Date	Number	Page
3/7/11	RVXX1006	1(3)

VNM, VNL, VHD, VT

RVXX1006, Inversion Valve, Fifth Wheel Air Release

Figure 1 — Position exhaust flapper in a downward plane.

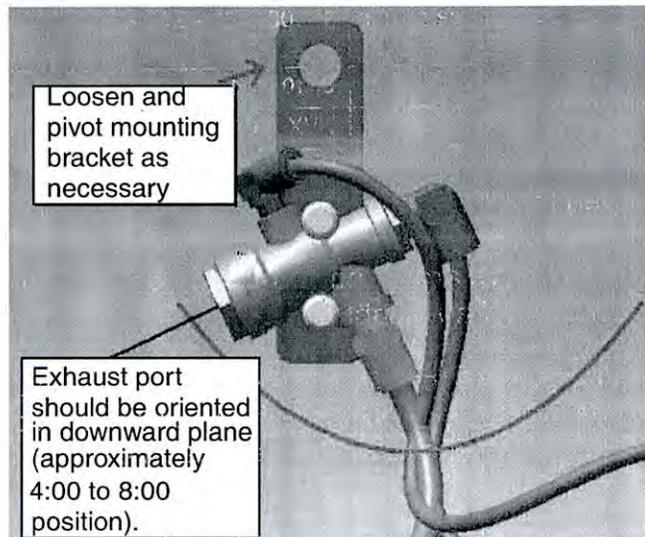
The inversion valve on the frame may be orientated where contaminants can enter the valve through the exhaust port. If this occurs, corrosion may occur, which can cause the valve to malfunction and in extreme cases possibly result in unintended opening of the fifth wheel's locking mechanism that holds the trailer's king pin.

The repair consists of performing a visual inspection of the TR-3 inversion valve in the TouchLoc 5th wheel control system to see if the exhaust port is pointed down (i.e. 4 to 8 o'clock), and replacement if it is not pointed down (i.e. 4 to 8 o'clock).

1. Visually inspect the TR-3 inversion valve for proper orientation (i.e. 4-8 o'clock position). If the orientation results in the exhaust port being outside of the 4-8 o'clock position, replace the valve with Volvo part number **85102791** (see Figure 1). All valves must be purchased from a Volvo dealer. Make certain that the existing or replacement valve is installed inside the frame rail with the exhaust facing in a downward plane. It may be necessary to remove and reposition the mounting bracket to ensure the TR3 inversion valve exhaust is facing in a downward plane. Use a grade 8 bolt and lock nut of the proper length to secure mounting bracket to frame. Torque to 140 +/- 24 Nm (103 +/- 18 ft-lb).

Repositioning the valve may cause the airline(s) to be too short. If this occurs, then replace the airline(s) that are too short.
